COMMITTEE ON JOINT SCHOOL BUILDINGS

Lavallee/Brensinger P.A. <u>Manchester Public Schools Project</u> Additional Services Authorization Form

RFC: Classroom Renovation

PROJECT: 390 Parker-Varney Elementary School

No. 00004

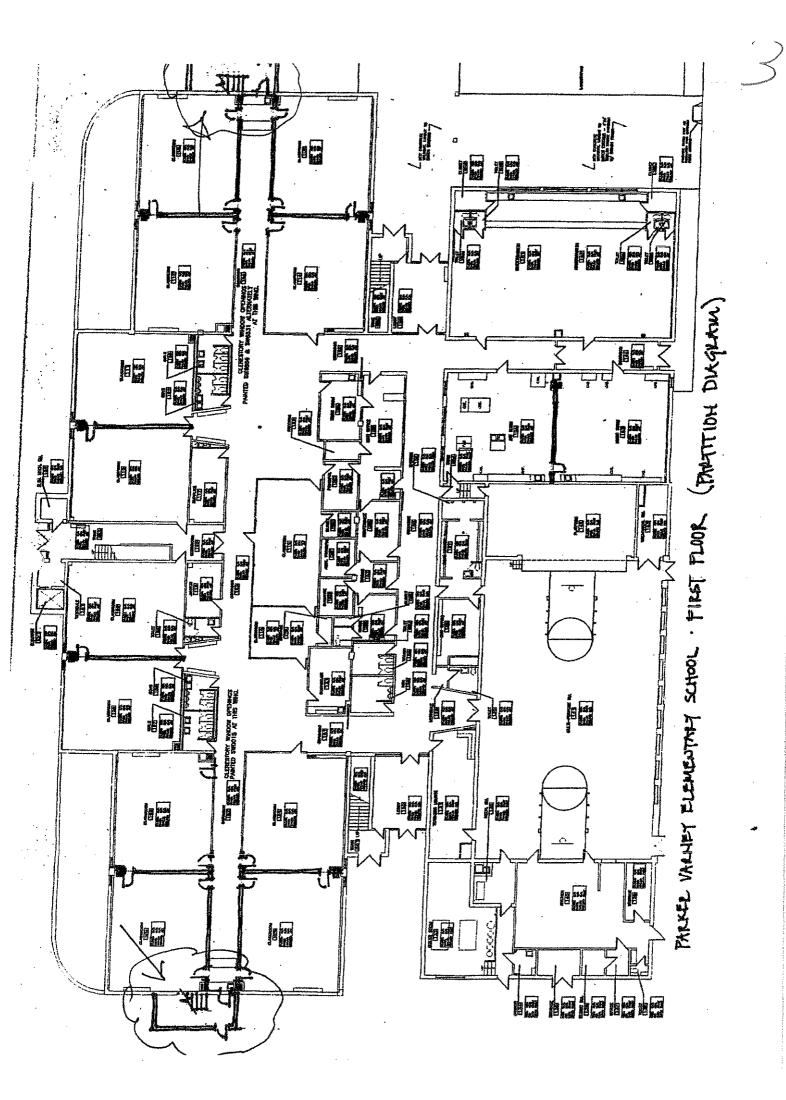
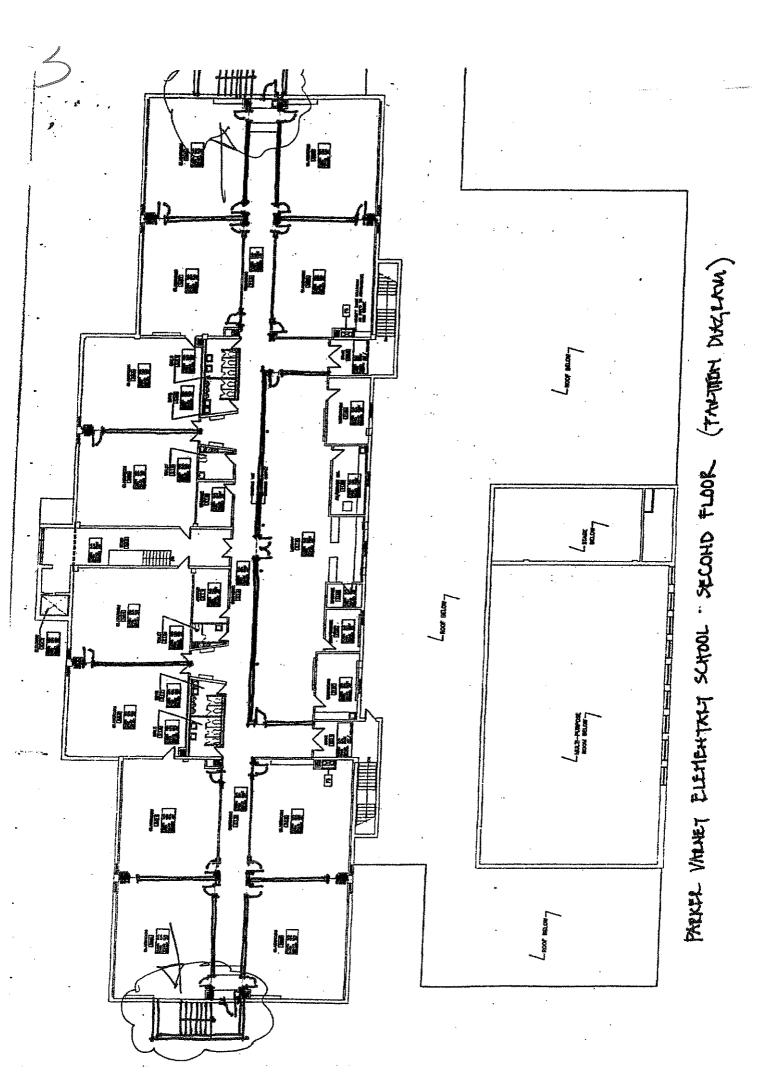
Renovations include the installation of demising partitions to for the conversion of existing open classroom areas at each end of the building into 4 sets of 4 individual classrooms (16 total); and the installation of permanent demising partitions in place of existing accordion-type partitions in the balance of classrooms else where in the building (10 total).

Provide a new stairway at each end of the building to ensure proper access and egress from these areas. Stairway can be interior or exterior of the existing building footprint whichever is most cost effective. Stairway to be metal pan with new raised disk rubber flooring at stairs and landings.

On the second floor, a new demising partition will be installed to separate the library from the open corridor, Shelving capable of accommodating existing program requirements shall also be provided.

Please refer to the attached diagram for conceptual scope outline. This diagram is for reference purposes only and is not intended to be a a design solution.

BULLETIN No. 00005

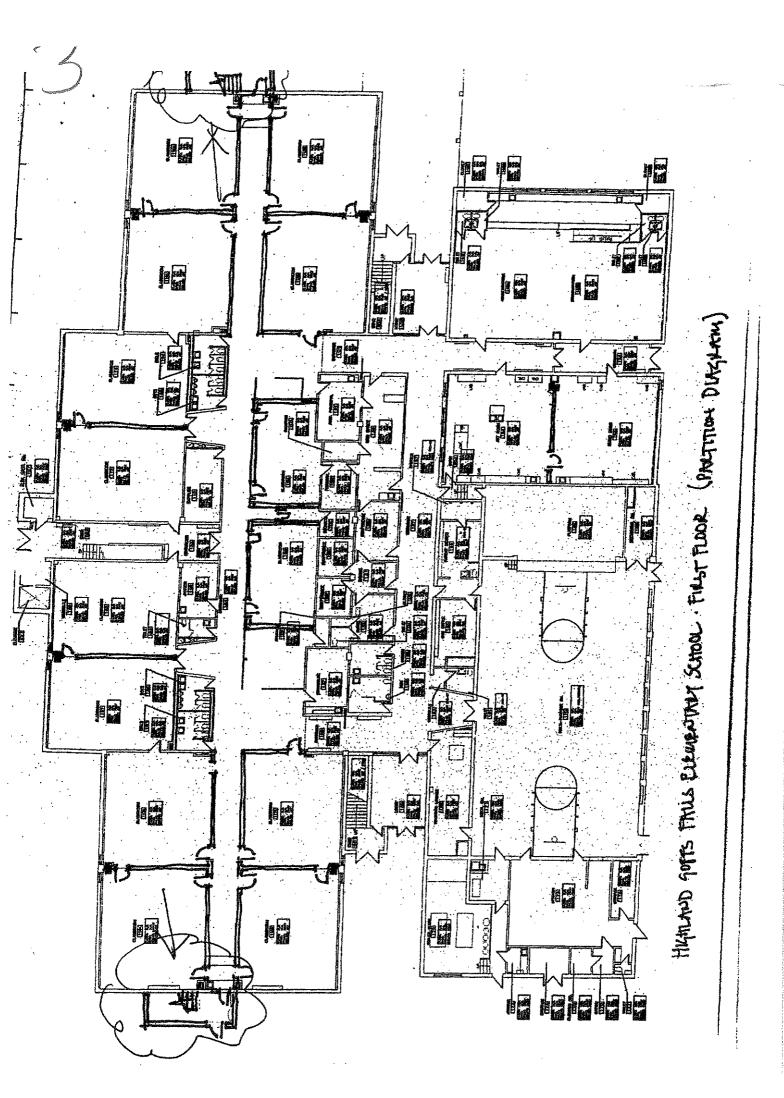
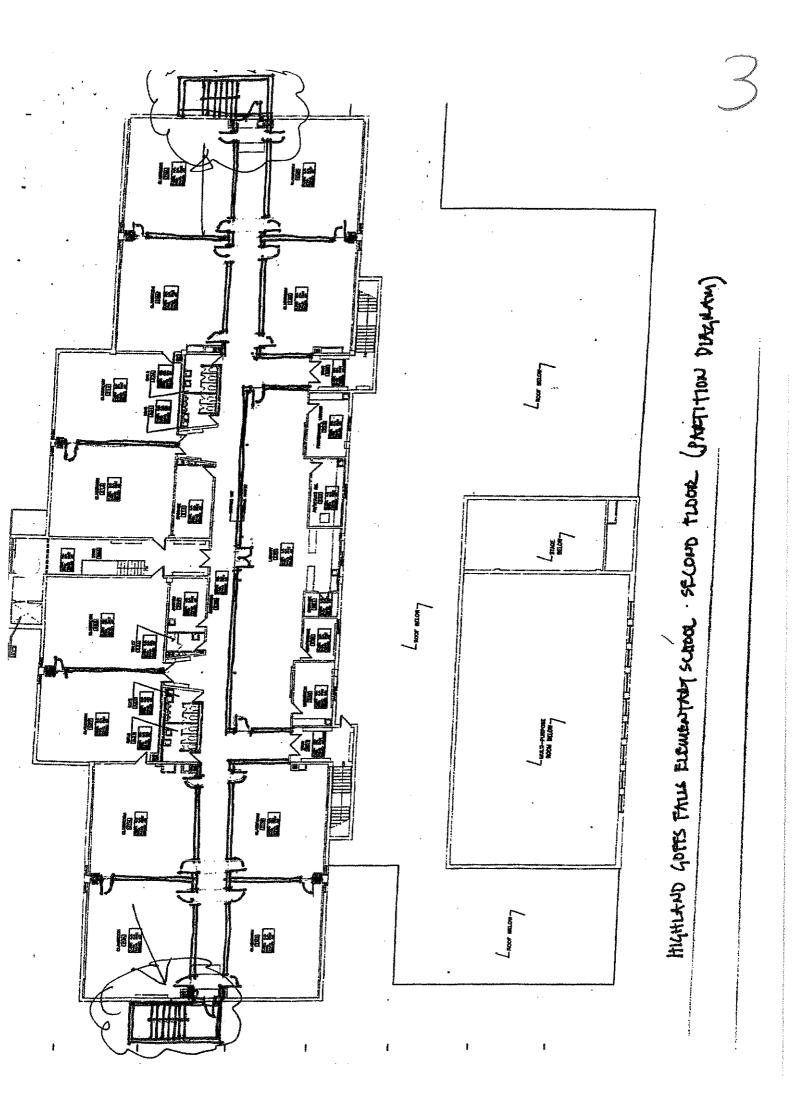
Renovations include the installation of demising partitions to for the conversion of existing open classroom areas at each end of the building into 4 sets of 4 individual classrooms (16 total); and the installation of permanent demising partitions in place of existing accordion-type and temporary partitions in the balance of classrooms else where in the building (12 total).

Provide a new stairway at each end of the building to ensure proper access and egress from these areas. Stairway can be interior or exterior of the existing building footprint whichever is most cost effective. Stairway to be metal pan with new raised disk rubber flooring at stairs and landings.

n the second floor, a new demising partition will be installed to separate the library from the open corridor. shelving capable of accommodating existing program requirements shall also be provided.
